US 63887869-01

Fault in crankshaft sensor

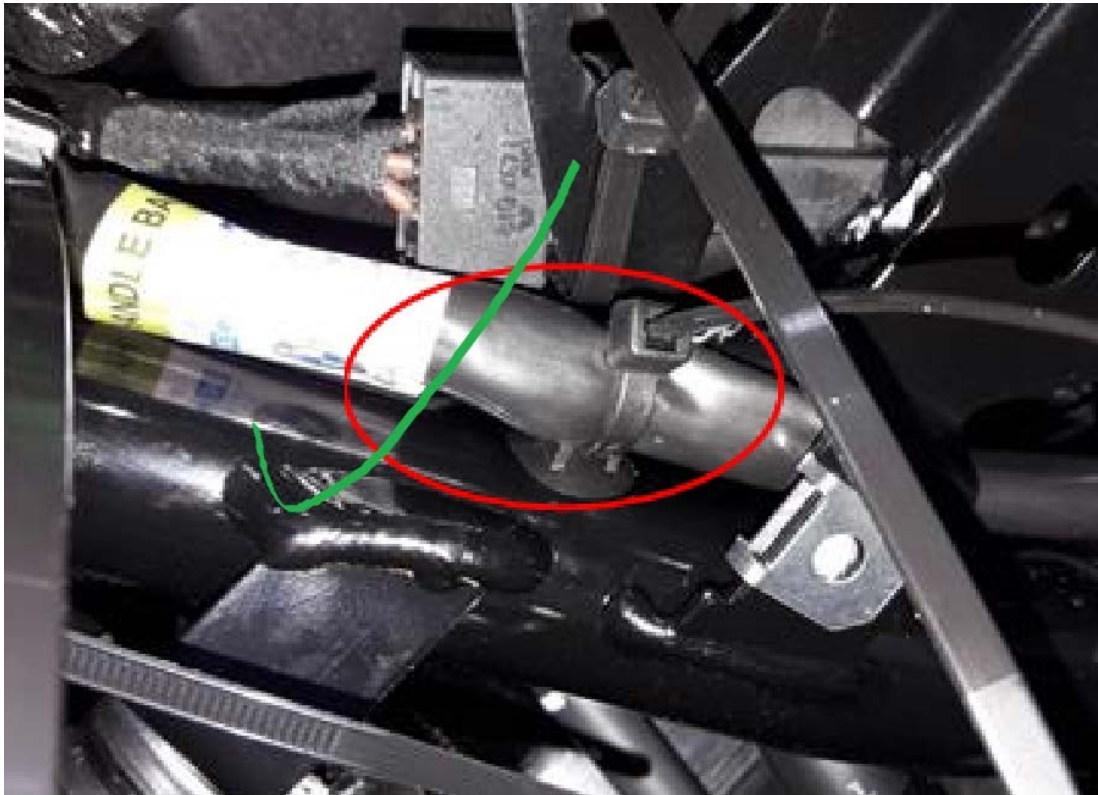
The plug in the area of the engine control unit must also be repositioned: It must be mounted BEHIND instead of IN FRONT OF the wiring harness, so that the lines there are no longer bent in an unacceptable manner! (see attachment)

Correct Placement

Incorrect Placement
